APPLICATION NO.	FILING DATE	FIRST NAMED INVENTOR	ATTORNEY DOCKET NO.	CONFIRMATION NO.
10/817,666	04/02/2004	Gunter Pielmeier	005777.109442	2976
29540	7590	08/06/2008		
DAY PITNEY LLP 7 TIMES SQUARE NEW YORK, NY 10036-7311			EXAMINER FONSECA, JESSIE T	
			ART UNIT 3633	PAPER NUMBER
			MAIL DATE 08/06/2008	DELIVERY MODE PAPER

DETAILED ACTION

Fig. 2: Huelsekopf (US 4,407,100)

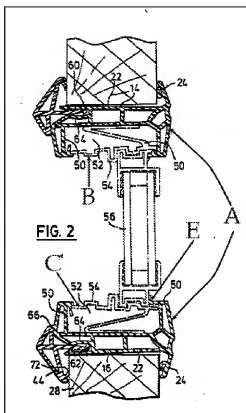
With regards to claim 1-3: Huelsekopf discloses a container (28) having a wraparound installation frame (10) connected to a window frame (A), wherein the interior side of the container (28) is equipped with a back square (12) that is connected to the installation frame (10) (figs. 1-3). The back square (12, figs. 1-3) of Huelsekopf would be considered to perform equally well to that of applicant's as it provide stability and alignment of the window to the container wall opening. Note the back square connected to installation frame is capable of being adjusted to the thickness of the container wall as the back square includes barbs (48) that may engage the installation frame at varying thicknesses.

Huelsekopf further discloses a "shutter frame" (B) received into the open upper frame portion of the wrap around installation frame (10), wherein the "shutter frame" (B) is interposed between the upper frame portion of the window frame (A) and installation frame (10) (fig. 3)

Huelsekopf further discloses cover (C) for placement in the grooves of the bottom and lateral frame portions of the installation frame (10), wherein the installation frame (10) is connected to the window frame (A) by means of a bracket (E) that is capable of snapping into the groove of the window frame (fig. 2). Note that any material has some
